LANL Single-Screen Characterization Well R-34 requires replacement,
version 07-22-08
by Robert H. Gilkeson, Registered Geologist

Figure 2. Predicted plume migration for sources released at the water table below Mortandad Canyon, based on a steady-state, with pumping, flow field.

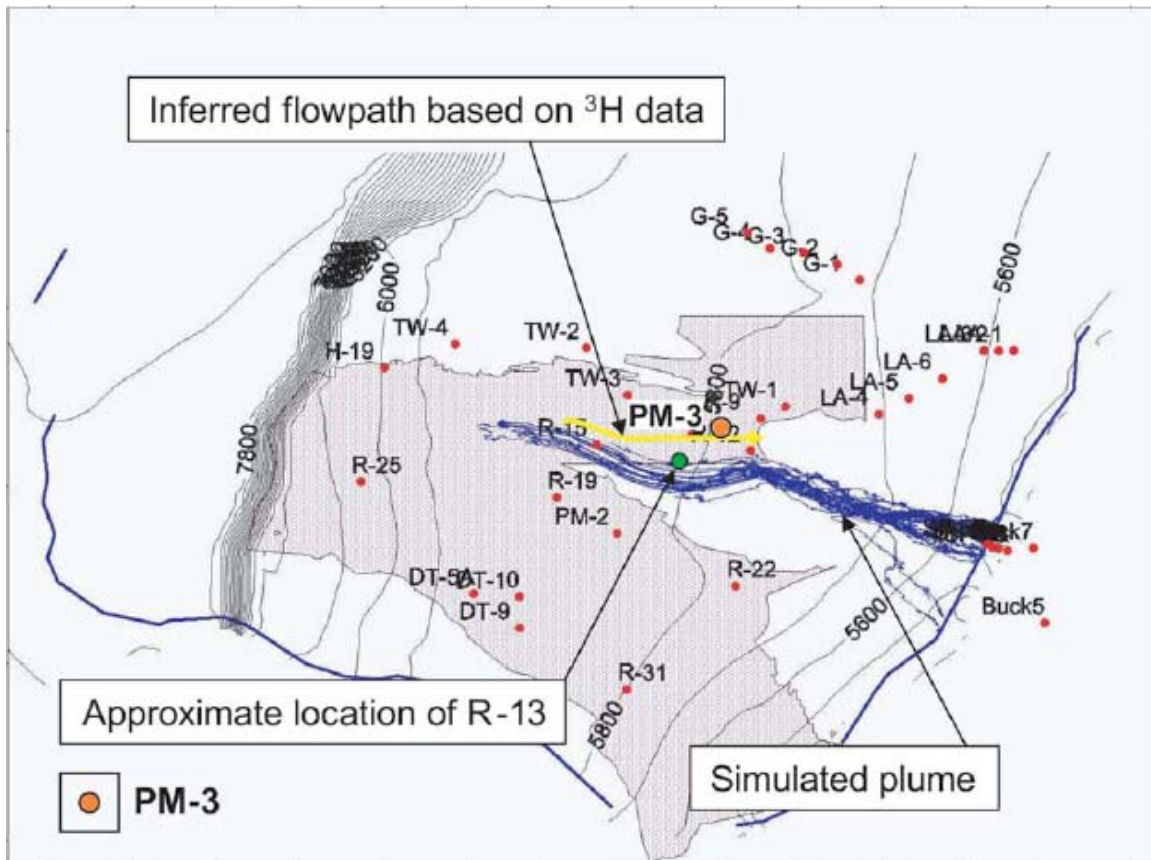
The groundwater in the regional aquifer along the plume pathway on Figure 2 is contaminated with hexavalent chromium at levels more than eight (8) times above the drinking water standard of the New Mexico Environment Department (NMED). The highest known hexavalent chromium contamination is at a location that is close to the property of the San Ildefonso Pueblo. LANL has no reliable monitoring wells for the investigation of groundwater contamination on the property of the San Ildefonso Pueblo and along the plume pathway in Figure 2.

Although the pumping tests in well R-34 and also in wells R-10 and R-10a produced spurious data that resulted in the calculation of an unreasonably slow speed of groundwater travel in the plume pathway displayed on Figure 2, LANL reports now present the unreasonably slow groundwater travel speed as accurate.

Figure 3. Effect of organic drilling fluids to form a new mineralogy in a zone surrounding the screened intervals that prevents detection and accurate measurement of LANL contaminants in water produced from the LANL characterization wells. The cartoon is an overhead view of the wells.

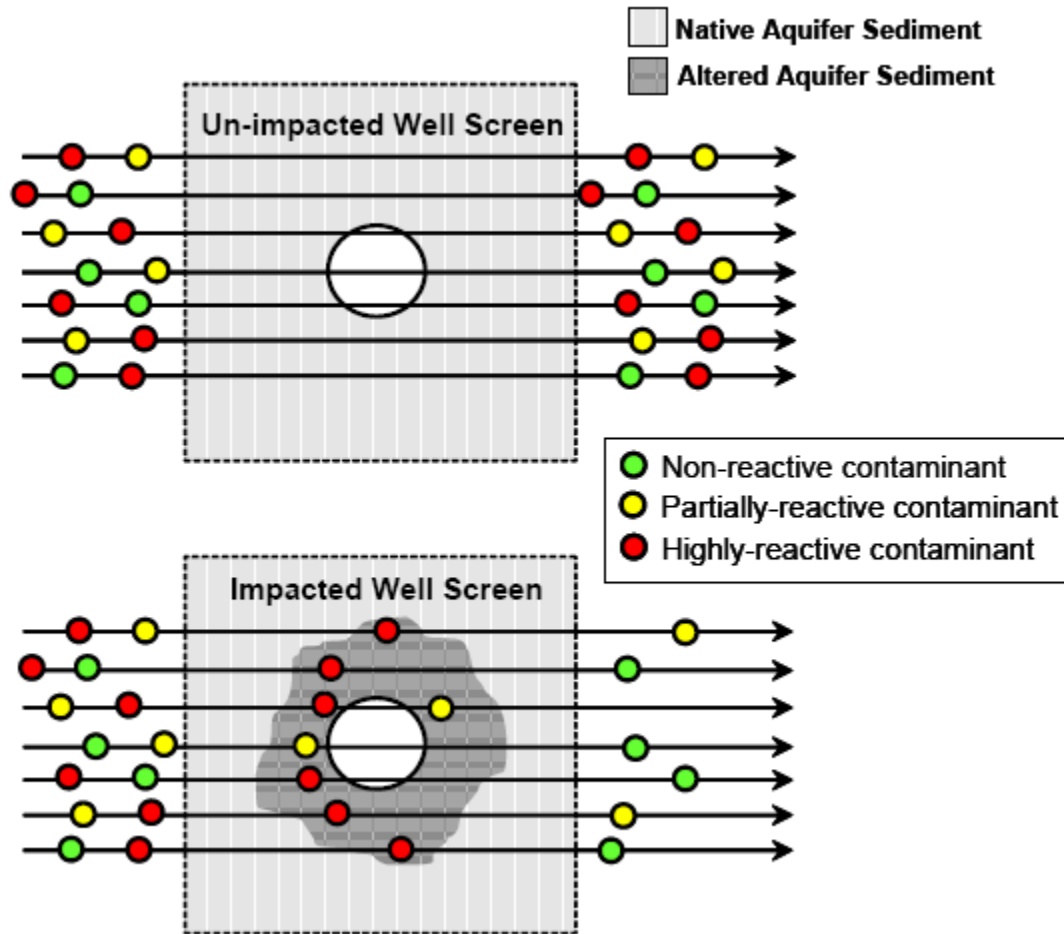
Figure 3 is a cartoon of the new mineralogy that was formed in the sampling zones of practically all of the LANL characterization wells (including wells R-34, R-10 and R-10a) by the organic drilling additives. The new mineralogy in the impacted zone surrounding the well screens are precipitates of iron and manganese that have very strong properties to prevent the detection of many of the LANL contaminants and especially the trace metal radionuclide contaminants that are listed above (i.e., isotopes of plutonium, americium, cesium, etc). These radionuclide contaminants are a special concern for reliable detection and accurate measurement in the regional aquifer at the locations of the LANL characterization well R-13 and LANL wells R-34, R-10 and R-10a on the property of the San Ildefonso Pueblo.

surrounding the screened interval as displayed in Figure 3. The high levels of total iron in the water samples collected over a period of the first two years may indicate high concentrations of suspensions of iron colloids that were formed by the microbial processes.

Figure 4. Hydraulic conductivity estimates in the regional aquifer. If multiple screens have been tested at a single location, the uppermost result is shown. Red line is the outline of the Laboratory.

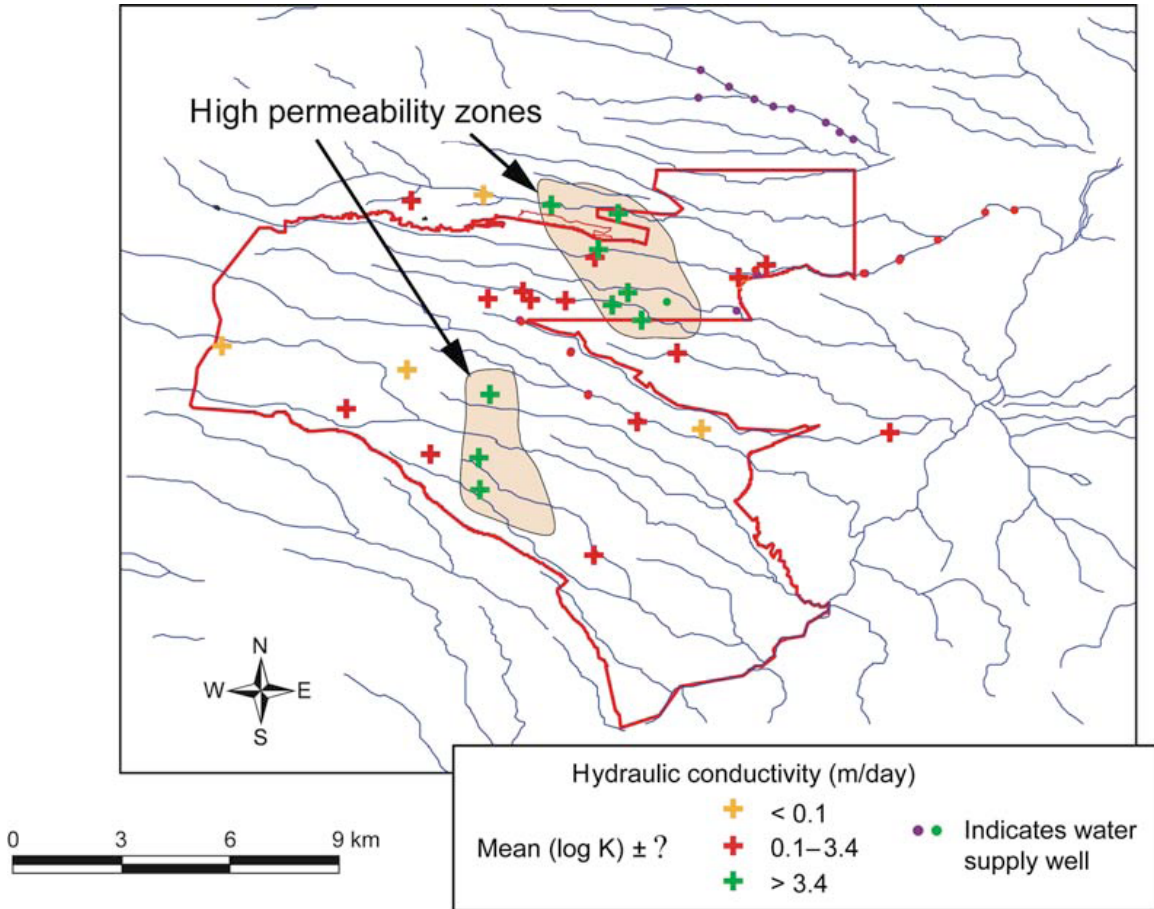
Figure 4 is a map from the Hydrogeologic Synthesis Report that shows two landscape areas in the central part of LANL where the regional aquifer has high permeability. The northern area covers 6.5 square miles and the southern area covers 4 square miles. The two areas are identified as having aquifer strata near the top of the regional aquifer with permeability (i.e., saturated hydraulic conductivity (Ksat)) greater than 3 meters/day (>10 feet/day). On the map, well R-34 is displayed as a red symbol at a location immediately south of the northern area with high permeability.

The conclusion in the LANL *Hydrogeologic Synthesis Report* that there are no high permeability zones (i.e., Ksat > 10 feet/day) east of LANL on the property of the San Ildefonso Pueblo is a serious mistake. The Schlumberger^R geophysics report for well R-34 identified a 72-ft thick section of saturated sediments at the top of the regional aquifer with a permeability much greater than 10 feet/day. Discrete layers within the 72-ft thick section may have Ksats greater than 50 and even greater than 100 ft/day. The description of the highly permeable sediments in the Schlumberger^R report are on page 9 of this exhibit.

The measured permeability values in well R-10 and the geophysics logs for wells R-10 and R-34 are proof that the "high permeability zones" displayed on Figure 4 are also present over a large area on the property of the San Ildefonso Pueblo. Furthermore, the zones with high permeability are along the plume pathway on Figure 2. It is a serious mistake that LANL reports do not recognize the high permeability of the regional aquifer over a large area on the property of the San Ildefonso Pueblo.
